Re: VARIANCE REQUEST  
CUBELLO/PULLER PROPERTY  
202 BAR HARBOR ROAD  
PASADENA, MD 21122  
G02019582

**NUMBER:** 2024-0208-V

### CONFIRMATION OF PRE-FILE

**PRE-FILE #:** 2024-0091-P  
**DATE:** 09/26/2024  
**STAFF:** Joan A. Jenkins (OPZ)  
Kelly Krinetz (OPZ)  
Subhash Dhr (I&P)

### VARIANCE PLAN

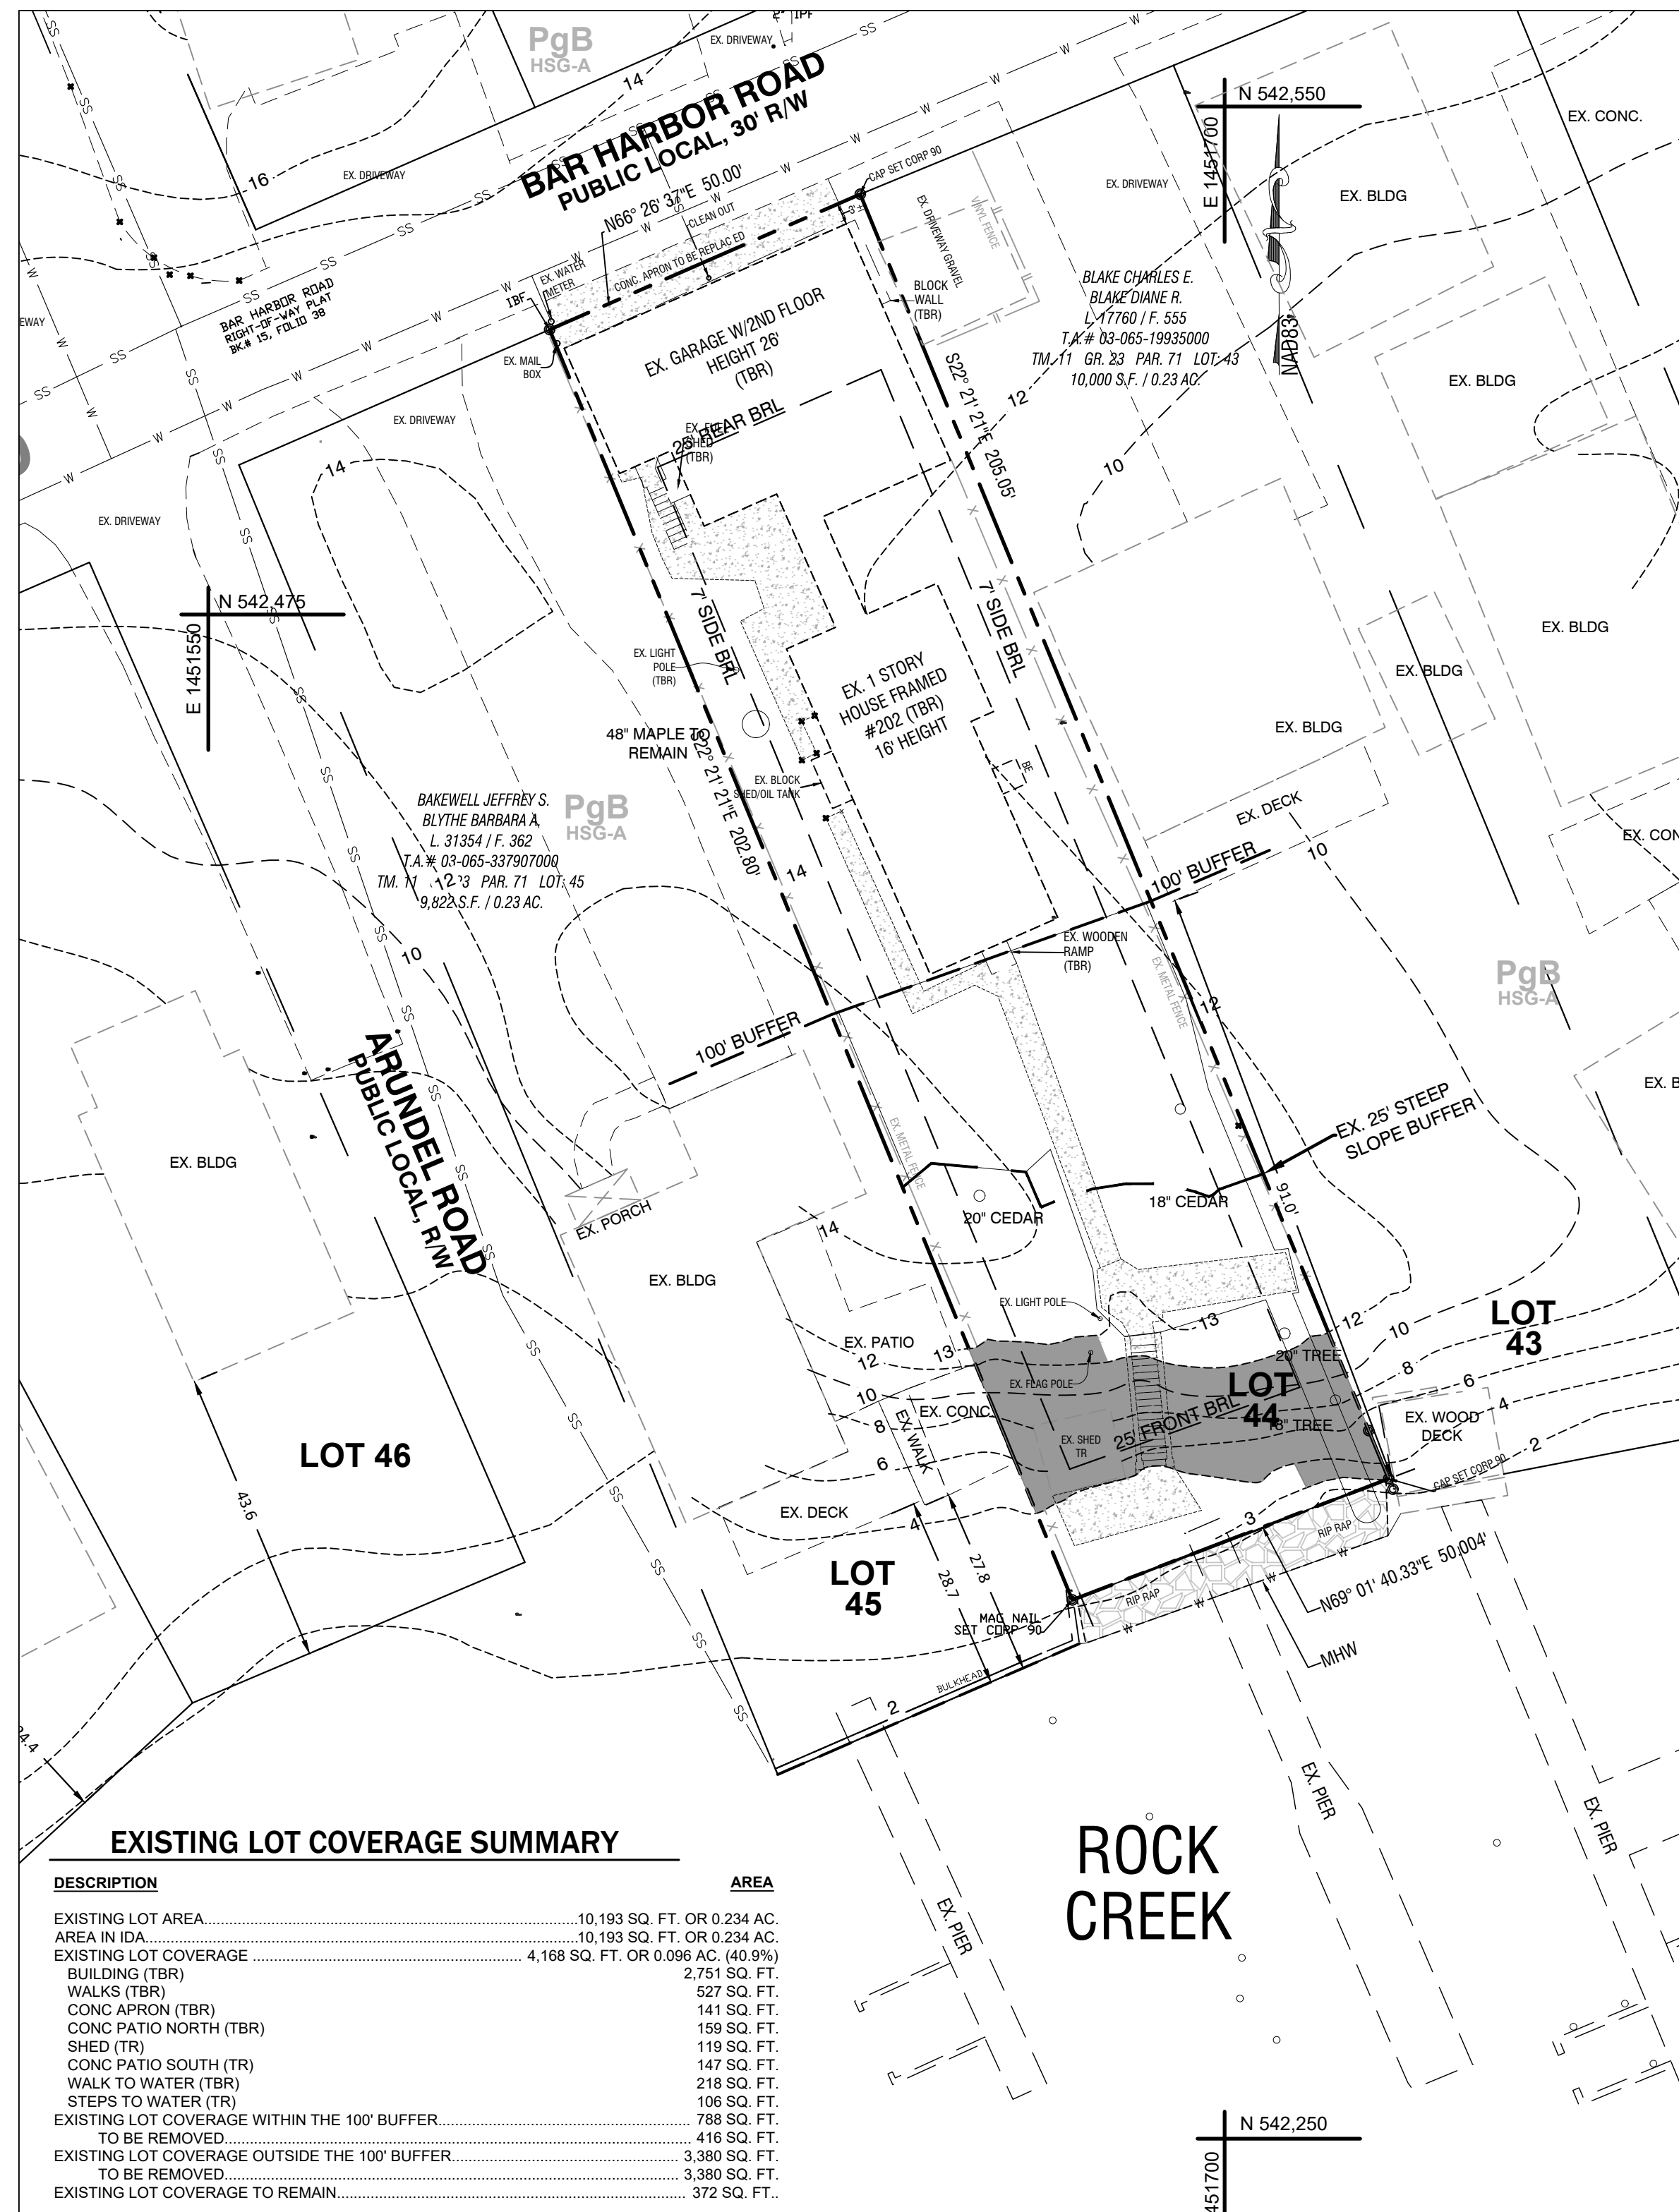
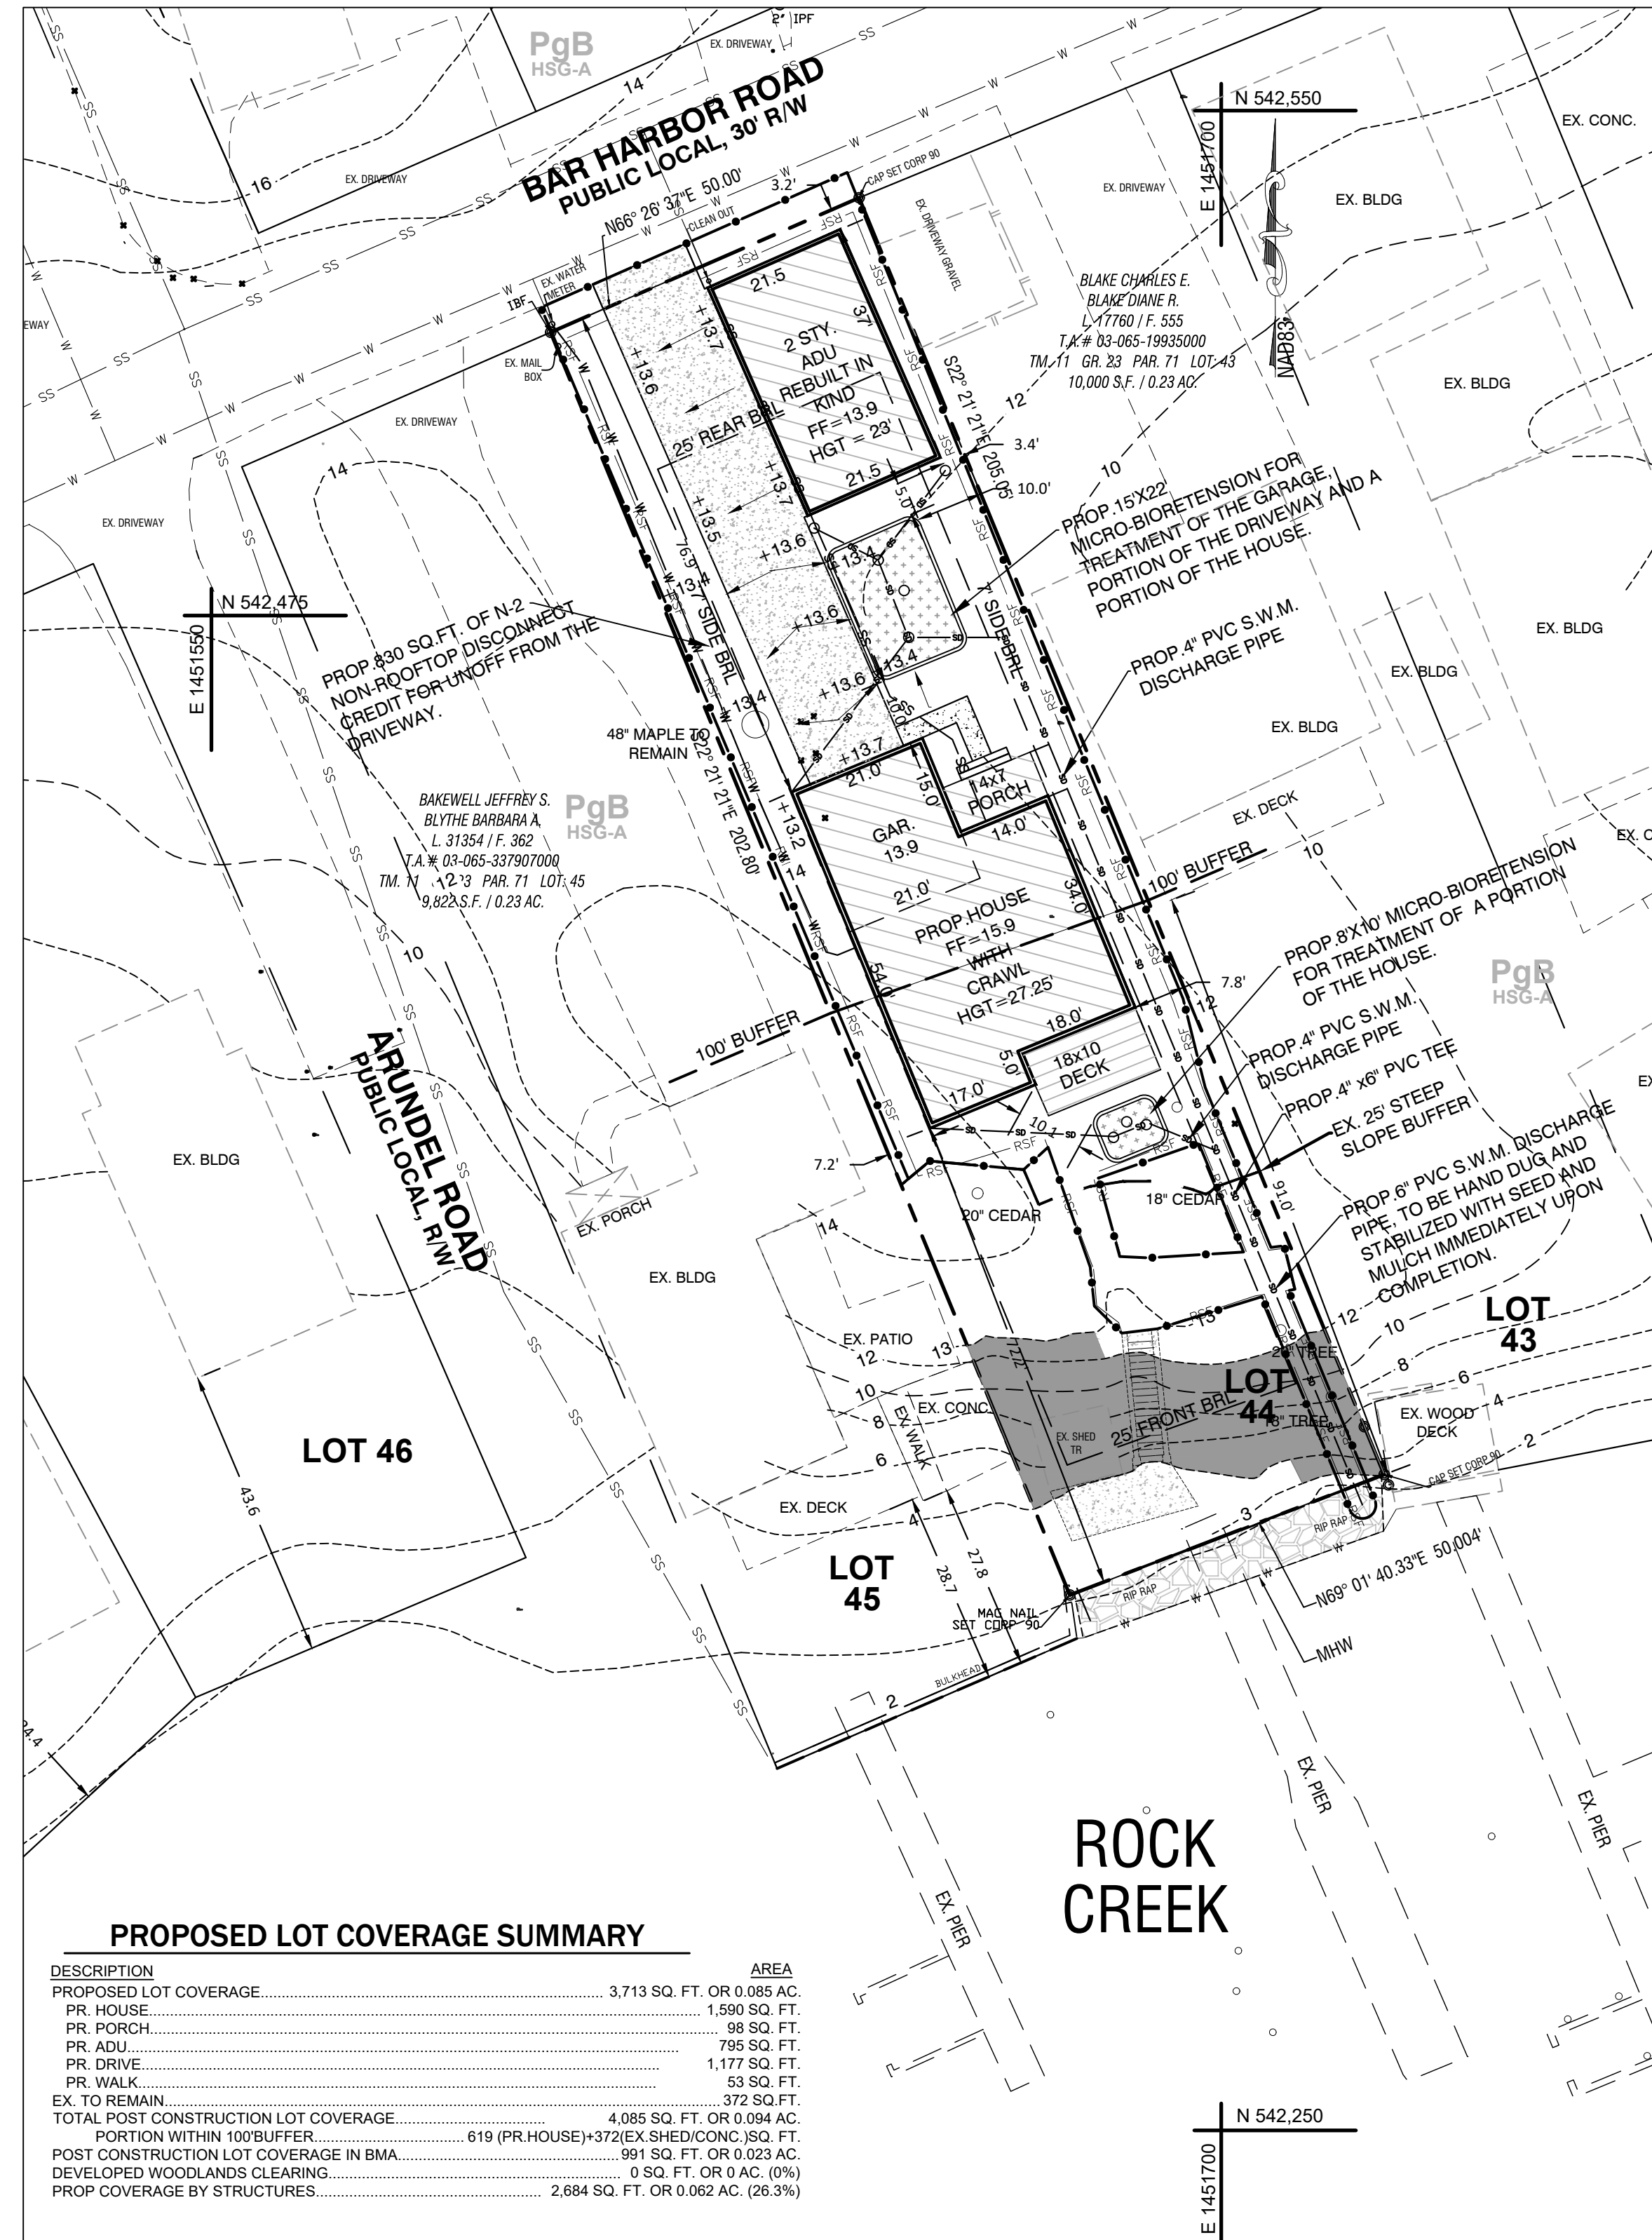
1. The site is located in the IDA of the Chesapeake Critical Area and in a Buffer Modification area.
  2. Approximately 50% of the proposed house is located in the 100 feet modified buffer Area.
  3. Two micro bio facilities are proposed for the stormwater management and one micro bio facility is located in the modified buffer area.
  4. The SWM, utility/Engineering design review for the site shall occur at the grading permit stage.
- Determination. We recommend that the development should be redesigned to remain outside of the buffer area. The decision is deferred to the Zoning Administration.

The existing dwelling on site is located outside of the 100 foot buffer. Article 17-8-702(b) states that an applicant shall not locate new coverage nearer to the shoreline than the existing dwelling and must design the proposed structures in order to maximize the buffer. The proposed development of this site does neither. The home is not pushed forward due to size, topography or unique characteristics of the lot but because a significant portion of the site will be encumbered by a proposed 22'x38' detached garage.

The improvements should be redesigned to remain outside of the buffer.

Site Plan: Indicate the number of stories and the height (in feet) in the area of both the proposed house and the detached garage.

Provide calculations for coverage by structure and percentage. The R5 district allows a maximum of 40% coverage by structure. The IDA does not have an impervious cover limitation so it is unnecessary.
